MEETING NOTICE

A meeting of the
Bayside Local Planning Panel
will be held in the Committee Room, Botany Town Hall
Corner of Edward Street and Botany Road, Botany
on **Tuesday 13 November 2018 at 6:00 pm.**

Bayside Local Planning Panel

Item No	6.1
Application Type	Section 4.55(1A) Application to modify approved mixed use development
Application No	SF18/2178
Lodgement Date	28/06/2018
Property	DA-16/150/06- 42 Church Avenue, Mascot
Ward	Mascot
Owner	Karimbla Property (No. 45) Pty Ltd
Applicant	Karimbla Constructions Services (NSW) Pty Ltd
Proposal	Section 4.55(1A) Application to modify Development Consent No. 16/150 to relocate the mailroom in the basement and relocate the courtyard fence to Unit G37 and modifications to conditions
No. of Submissions	Nil
Cost of Development	0
Report by	Michael McCabe, Director of City Futures

Figure 2. Proposed extension of Unit G37 terrace

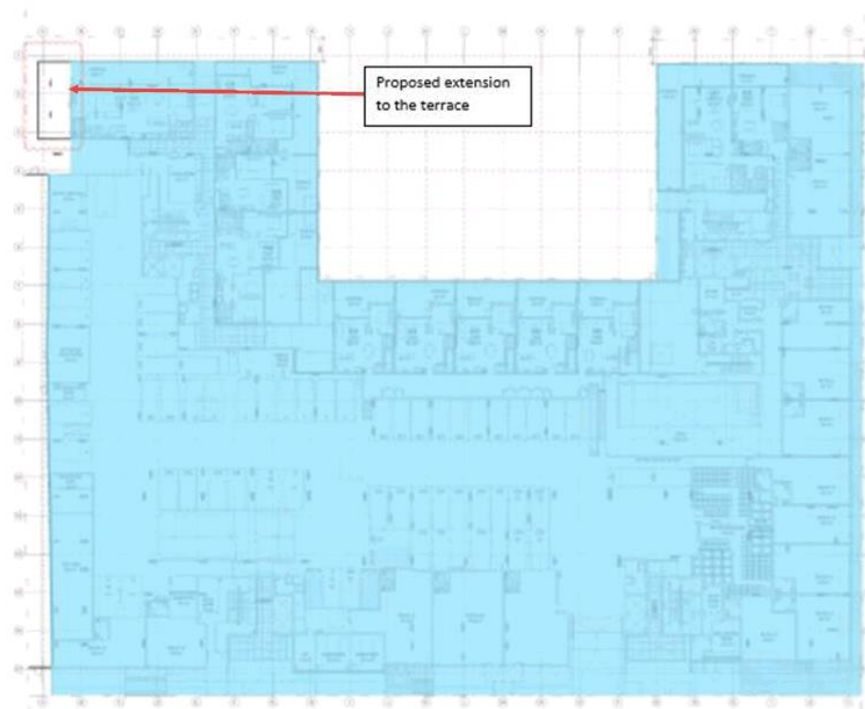
The modification will result in a reduction in the approved 3 metre setback from the western boundary to now achieving a 2 metre setback. The loss in one metre is not considered significant as the proposal will retain access off Galloway Street to Church Avenue and will not impact the amenity of the adjoining development located to the west. Therefore the proposal is minor therefore this modification is supported.

Figure 5. Proposed location of the mailroom within Basement Level

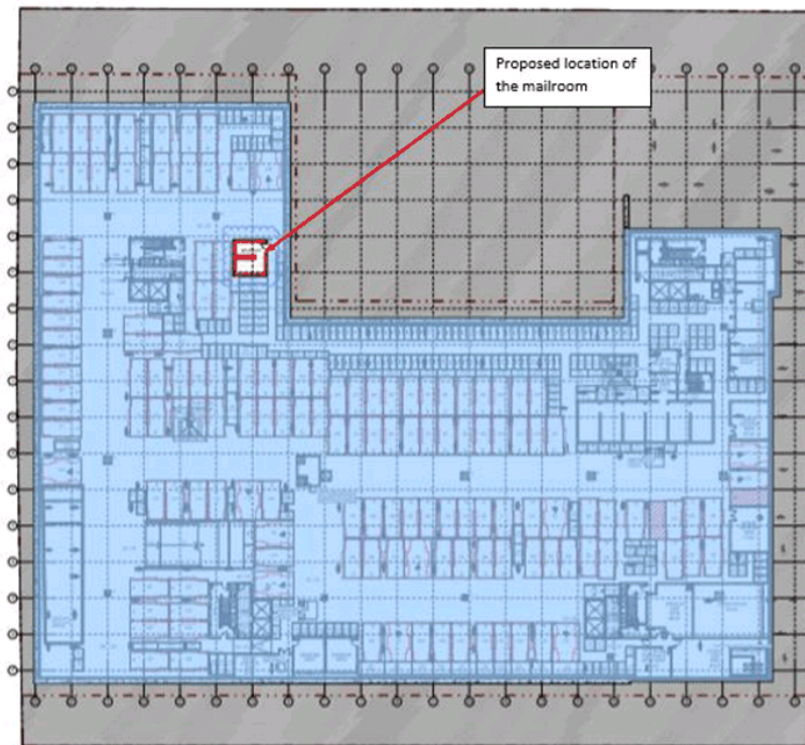
The proposed modifications are supported with the exception of the relocation of the mailroom into the basement. The proposed location of the mailroom will not be easily identifiable and does not promote good amenity and meeting place for the residents. Additionally the proposed location is not consistent with the controls of Part 4C of the BBDCP 2013 as well as the objectives of the Apartment Design Guide. Therefore the mailboxes of each individual tower should be located within each respective tower lobby. Condition No. 64(g) is to be retained within the consent.

The basement does not provide for an inviting space for residents to meet and collect mail as all mail boxes are compacted within one small room in a section of the car parking level which is not distinguishable or identifiable than what it would be if it was located at the lobbies. Additionally the mailboxes are not clearly visible from the street or from the public domain as required within Part 4C of the BBDCP 2013 as well as prescribed within Objective 3C-2 of the ADG. Therefore the proposed modification is not supported.

Figure 4 - Existing front landscaped area.
Source: Survey Plan Norton Survey Partners

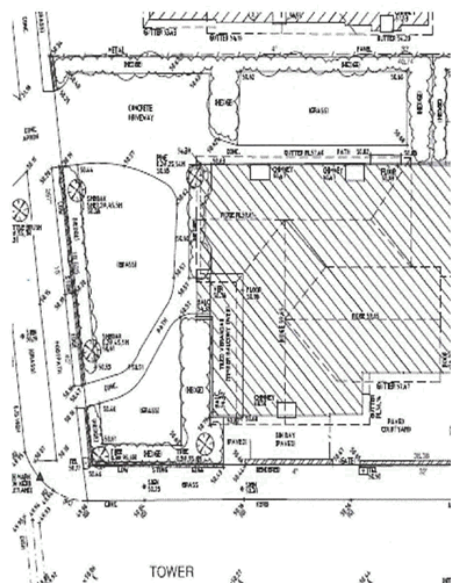
The primary frontage of the overall site is to its southern quadrant facing Forest Road. However, independent entrance off Towers Place has been planned for the proposed addition. The proposed addition will feature a front setback of 2.3 metres to Towers Place. The adjacent development to the north (being No. 2 Towers Place) has a front setback, which varies from approximately 3.6 to 4.5 metres to the boundary. The proposed front setback of 2.3m including the first floor component is not compatible with the setback of the adjoining building and those on the opposite side of Towers Place, whose average front setback is at least 6 metres.

In addition to the above, the proposal is utilising the front setback and front curtilage of the existing building for carparking. The existing limited concrete area on the Forest Road frontage will be significantly increased to allow maneuvering of vehicles and the addition of two carparking spaces. The existing carparking space will be relocated behind the building line reducing the landscaped area further. Refer to figures below. One of the carparking spaces is to be provided for one of the new units at the rear, which is not practical as there is no access to the carparking space from within the property. The provision of additional parking at the front is to the detriment of the existing attributes of the streetscape and is not supported.

Figure 5 - Proposed front landscaped area
Source: Landscape Plan BKA Architecture

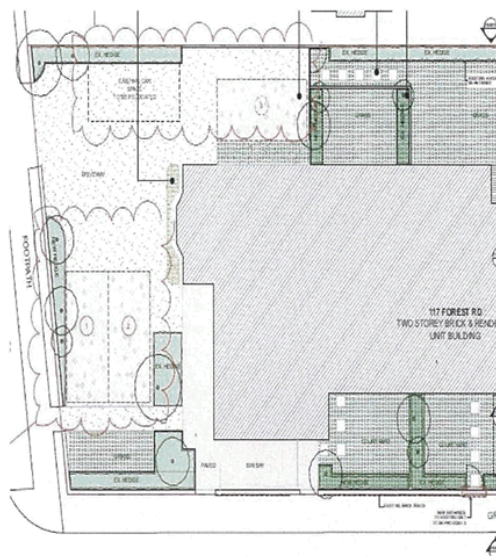
The proposed addition will not have a front door/living room/kitchen window addressing the street, with the building's frontage and entry points not being readily apparent from the street.

Figure 6 - DCP landscaping provision for low density areas

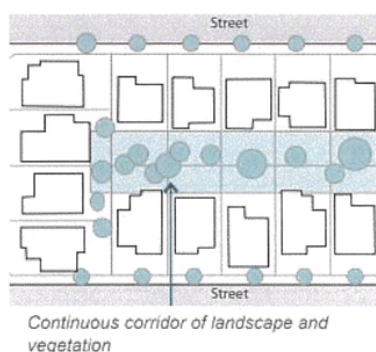
The proposal complies with the minimum 15% landscaped area required under this clause. However, the proposal compromises the existing front setback, which is an important feature of the site with the addition of three carparking spaces. The use of the existing front garden for parking and the proposed rear addition compromise the streetscape and the environmental amenity. The proposal removes the existing landscaping corridor characteristic of low density areas and as recommended by the DCP (refer to diagram below). The proposal is not consistent with the objectives of this clause.
